**City of Phoenix**  
PLANNING AND DEVELOPMENT SERVICES

**Staff Report: Z-3-10-5**  
**(Grand Canyon University PUD)**  
September 20, 2010

**Alhambra Village Planning Committee Meeting Date** September 28, 2010  
**Planning Commission Hearing Date** October 13, 2010  
**Request From:** R1-6 (single family residential/private university) (96.9 acres) and R-5 (office/multi-family/private university) (5.0 acres)  
**Request To:** PUD (Planned Unit Development) (101.9 acres)  
**Proposed Use** University campus and related uses  
**Location** Approximately 640 feet east of the northeast corner of Camelback Road and North 35th Avenue  
**Owner** Grand Canyon Education Incorporated  
**Applicant/Representative** Paul Gilbert  
 Beus Gilbert PLLC  
**Staff Recommendation** Approval, subject to stipulations

*Building setbacks for Grand Canyon University  
Planned Unit Development*

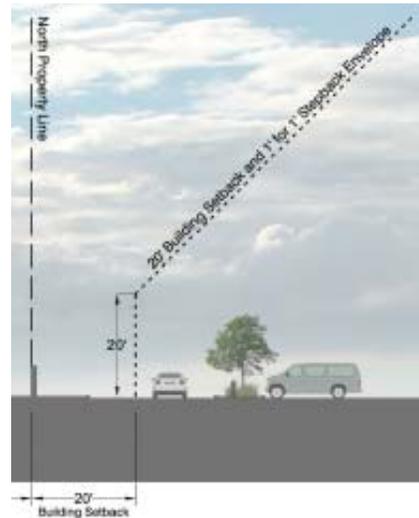
**Setbacks** –The purpose of this section is to define the setbacks for the perimeter of the site, providing appropriate standards depending on the adjacent land uses. Generally, perimeter landscape setbacks are an average of 25 feet and building setbacks range from 50 feet on the arterial streets to 20 feet along the other property lines. Additionally, building setbacks adjacent to residential uses along the north and west property lines (identified in Diagram G.11.) and around the parcel at the northeast corner, include a stepback provision.

- b. Amend Diagram G.2. to reflect landscape setbacks an average of 25 feet.
  - c. P. 30, paragraph 2, line 5 – After the word “height”, provide a reference to Diagram G.11.

# CONCEPTUAL SITE PLAN

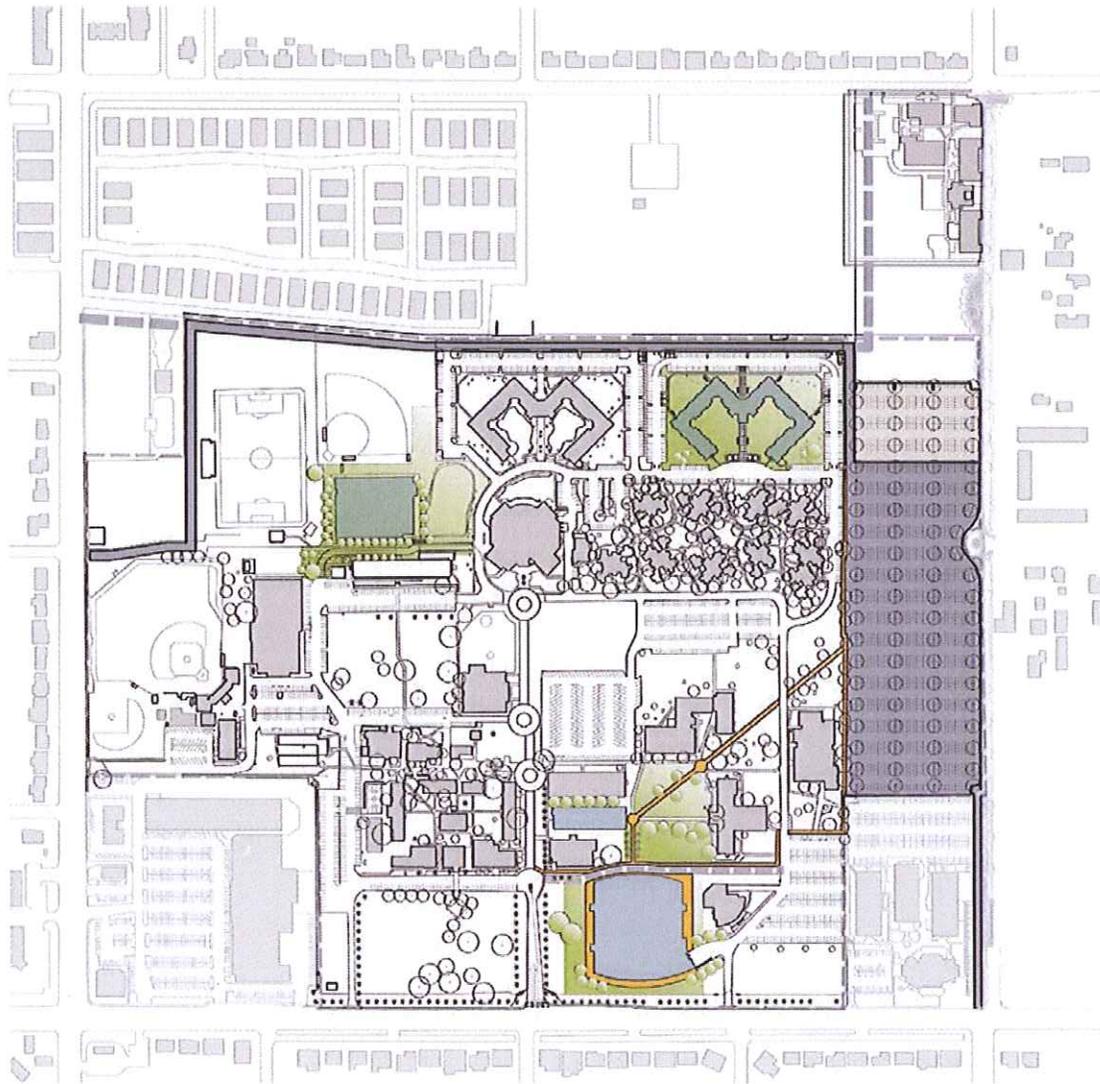
10. A Traffic Impact Statement has been submitted to the Street Transportation Department and review comments have been transmitted to the applicant. There are some discrepancies with the Traffic Impact Statement and the Vehicular Circulation Diagram in the PUD narrative. For example, they indicate that the entrance at the 31<sup>st</sup> Avenue alignment is a major access point, however there is no right-of-way in place at that location and permission to access across the private parcels has not been secured. As the PUD narrative may obtain approval prior to the approval of a Traffic Impact Study, the Vehicular Circulation Diagram title should be amended to indicate that it is conceptual.
11. Development and use of the site is subject to all applicable codes and ordinances. Zoning approval does not negate other ordinance requirements and other formal actions may be required.

4. That the Traffic Impact Statement shall be reviewed and approved by the Street Transportation Department prior to Preliminary Site Plan approval by the Planning and Development Services Department. The developer shall be responsible for any additional street right-of-way dedications and construction improvements.
